Referee #1:

The manuscript titled “Development and deployment of a mid-cost CO₂ sensor monitoring network to support atmospheric inverse modeling for quantifying urban CO₂ emissions in Paris” is generally well written and scientifically justified. We recommend it to be published after addressing the following points.

Figure S5. Site-to-site distance in kilometers. The distances to the nearest site for each site are highlighted in bold black font (read by rows) and are summarized in the table.

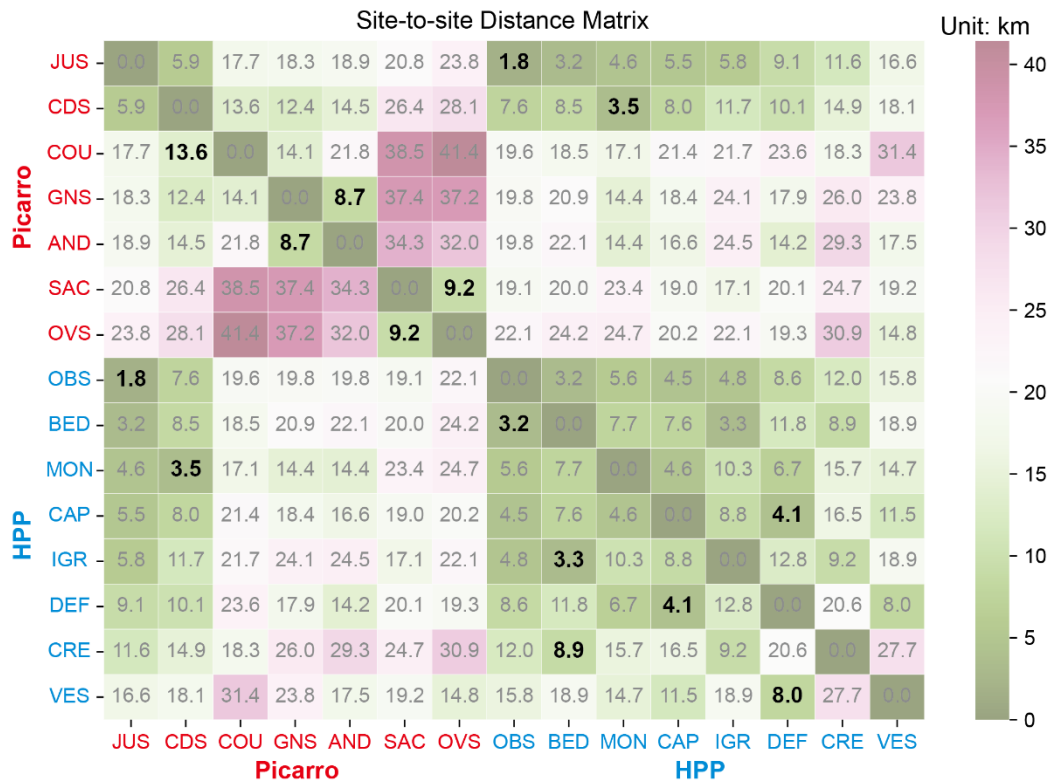
It would be helpful to have additional discussion of the spatial density of the network. The reader can deduce this from Figure 1, but average distance to the nearest site would be helpful to include in Section 2.4. How does the spatial density of the HPP network compare to the density of the Picarro network? How does the HPP spatial density compare to the previous studies of similar moderate-cost sensor networks (i.e. Wu et al., 2016; Turner et al., 2016)?

We thank the referee for the positive comments on our manuscript and the valuable suggestion concerning the spatial density of the network. The following figure shows the distances between sites in kilometers for the real urban CO₂ monitoring network containing 15 sites in this study. The average distance to the nearest site in the CRDS Picarro network is 8.7km, while for the HPP network, it is 4.9 km. In the combined CRDS Picarro and HPP network, this average distance reduces to 6.1 km. Both Wu et al. (2016) and Turner et al. (2016) conducted observing system simulation experiments (OSSEs) using pseudo-measurement networks. Wu et al. (2016) evaluated the potential of inversion with networks consisting of 10, 30, 50, or 70 stations. In Turner et al. (2016), the pseudo-measurement network included 34 sites at roughly 2 km spacing covering an area of roughly 400 km². Therefore, the real HPP network with 8 sites used in this study has a lower spatial density compared to the pseudo-measurement networks analyzed in the two previous OSSE studies.

We have added the following sentences in section 2.4 and Figure S5 in the supplement:

“Figure S5 shows the distances between stations in kilometers for the CO₂ monitoring network in this study. The average distance to the nearest site in the CRDS network is 8.7 km, while for the HPP network, it is 4.9 km. In the combined CRDS and HPP network, this average distance reduces to 6.1 km.”

Figure S4. The evolution of target gas injection duration in relation to the differences in CO₂ concentration between the other 4 minutes and the 3rd minute at one HPP sensor (HPP3), with a daily injection of target gas lasting 5 minutes over 26 days at LSCE.

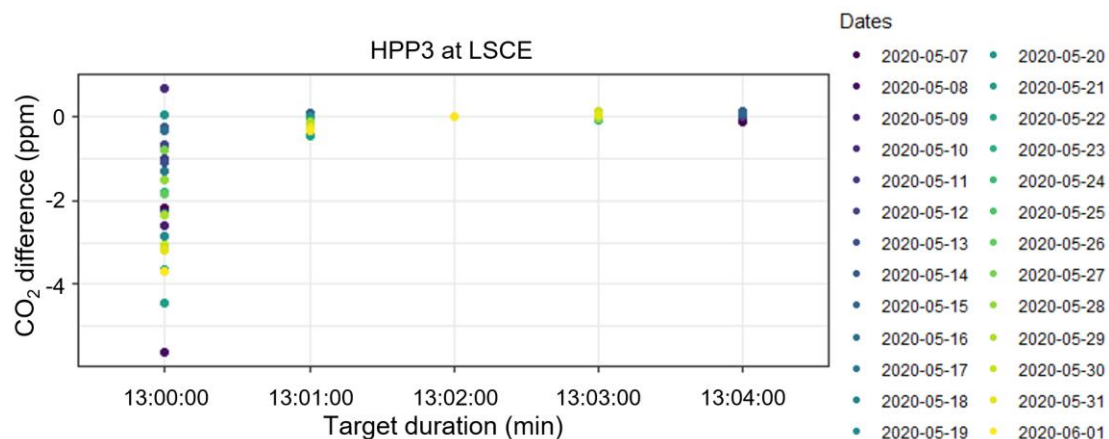
Page 5: In lines 35-37, the authors describe the target gas calibration using only 2 minutes to allow for flushing, but the calibration in parallel with the CRDS instrument requires 7 minutes to flush as described in lines 16-17. Could the authors provide justification for the shorter flushing time?

We have added the following paragraph in the supplement (Text S1 and Figure S4) to explain the settings for these two flushing times:

"To mitigate delays in sensor responses and ensure stability, thorough CO₂ flushing of the sensor cell is necessary. During the CO₂ correction coefficient IC_1 determination process, we sequentially sampled CO₂ mole fraction for a duration of 10 minutes, with 7 minutes dedicated to flushing and only the last 3 minutes of data used. During the on-site daily target gas injection for the $CO_{2offset}$ calculation, we sampled CO₂ mole fraction for a duration of 3 minutes, with 2 minutes of flushing and only the last minute of data used.

The differences in flushing times are due to two reasons. First, the CO₂ correction coefficient IC_1 is determined through a multipoint CO₂ regression using the seven mole fraction values

assigned within the 400–600 ppm range. Conversely, the CO₂ concentration in the target tank (which contains dry compressed natural air, pressurized at 200 bars and calibrated in CO₂) is supposed to be close to the ambient air CO₂ concentration on-site during midday. The step between two different CO₂ concentrations in the IC_1 determination process is greater than that during the target tank injection for drift correction, thus requiring a longer flushing time to achieve stabilization. Second, the CRDS and the mid-cost HPP sensor do not measure at the same flow rate, approximately 0.25 LPM for the CRDS and about 1 LPM for the HPP. They also have different precision targets. The CRDS sensor requires an extended period of target gas measurements to achieve a stability of less than 0.05 ppm, which is suitable for applications beyond this specific intercomparison. Therefore, the flushing time in the IC_1 determination process, when the HPP sensor measures in parallel with the CRDS, is expected to be longer. Before implementing this setting, we carried out several sensitivity tests on the sensor performance with a daily injection of target gas lasting 5 minutes at LSCE laboratory. The following figure shows the evolution of target gas injection duration in relation to the differences in CO₂ concentration between the other 4 minutes and the 3rd minute at one HPP sensor (HPP3) over 26 days. It demonstrates that a 3-minute target gas injection, specifically utilizing the 3rd minute data, proved to be sufficient. The added value of the 4th- and 5th- minute injection is rather limited. Therefore, the choice of a two-minute flush serves as a good compromise between maintaining good sensor performance (ensuring a target accuracy of 1 ppm) and minimizing gas consumption (thereby extending the lifespan of the tank and reducing associated maintenance requirements).”

Figure S4. The evolution of target gas injection duration in relation to the differences in CO₂ concentration between the other 4 minutes and the 3rd minute at one HPP sensor (HPP3), with a daily injection of target gas lasting 5 minutes over 26 days at LSCE.

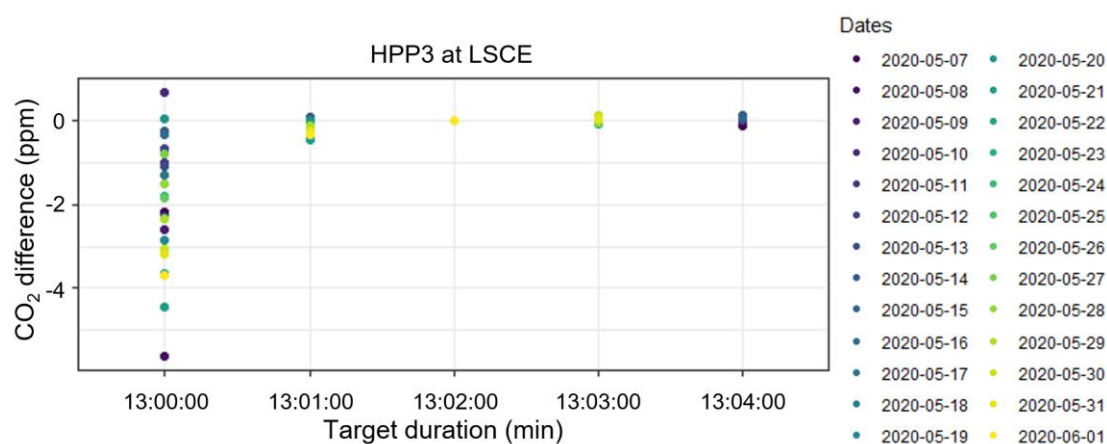
Firstly, on page 5, line 17, the authors write: "measuring dry air from two target cylinders with known CO₂ mole fractions. ... for a duration of 10 minutes, utilizing only the last three minutes of data", when discussing the calibration. Later in that paragraph, they say, "The target gas is injected ... for a duration of 3 minutes and only the last-minute data are used" to deal with sensor drift. It would be helpful if the authors commented on the sufficiency of the three minutes of target gas measurement. Is the measurement stable after two minutes? Did the authors run the target gas for longer periods and determine this was optimal for eliminating sensor drift while minimizing gas consumption?

We have added the following paragraph in the supplement (Text S1 and Figure S4) to explain the settings for these two flushing times:

"To mitigate delays in sensor responses and ensure stability, thorough CO₂ flushing of the sensor cell is necessary. During the CO₂ correction coefficient IC_1 determination process, we sequentially sampled CO₂ mole fraction for a duration of 10 minutes, with 7 minutes dedicated to flushing and only the last 3 minutes of data used. During the on-site daily target gas injection for the $CO_{2_{offset}}$ calculation, we sampled CO₂ mole fraction for a duration of 3 minutes, with 2 minutes of flushing and only the last minute of data used.

The differences in flushing times are due to two reasons. First, the CO₂ correction coefficient IC_1 is determined through a multipoint CO₂ regression using the seven mole fraction values assigned within the 400-600 ppm range. Conversely, the CO₂ concentration in the target tank (which contains dry compressed natural air, pressurized at 200 bars and calibrated in CO₂) is supposed to be close to the ambient air CO₂ concentration on-site during midday. The step between two different CO₂ concentrations in the IC_1 determination process is greater than that during the target tank injection for drift correction, thus requiring a longer flushing time to achieve stabilization. Second, the CRDS and the mid-cost HPP sensor do not measure at the same flow rate, approximately 0.25 LPM for the CRDS and about 1 LPM for the HPP. They also have different precision targets. The CRDS sensor requires an extended period of target gas measurements to achieve a stability of less than 0.05 ppm, which is suitable for applications beyond this specific intercomparison. Therefore, the flushing time in the IC_1 determination process, when the HPP sensor measures in parallel with the CRDS, is expected to be longer.

Before implementing this setting, we carried out several sensitivity tests on the sensor performance with a daily injection of target gas lasting 5 minutes at LSCE laboratory. The following figure shows the evolution of target gas injection duration in relation to the differences in CO₂ concentration between the other 4 minutes and the 3rd minute at one HPP sensor (HPP3) over 26 days. It demonstrates that a 3-minute target gas injection, specifically utilizing the 3rd minute data, proved to be sufficient. The added value of the 4th- and 5th- minute injection is rather limited. Therefore, the choice of a two-minute flush serves as a good compromise between maintaining good sensor performance (ensuring a target accuracy of 1 ppm) and minimizing gas consumption (thereby extending the lifespan of the tank and reducing associated maintenance requirements).”
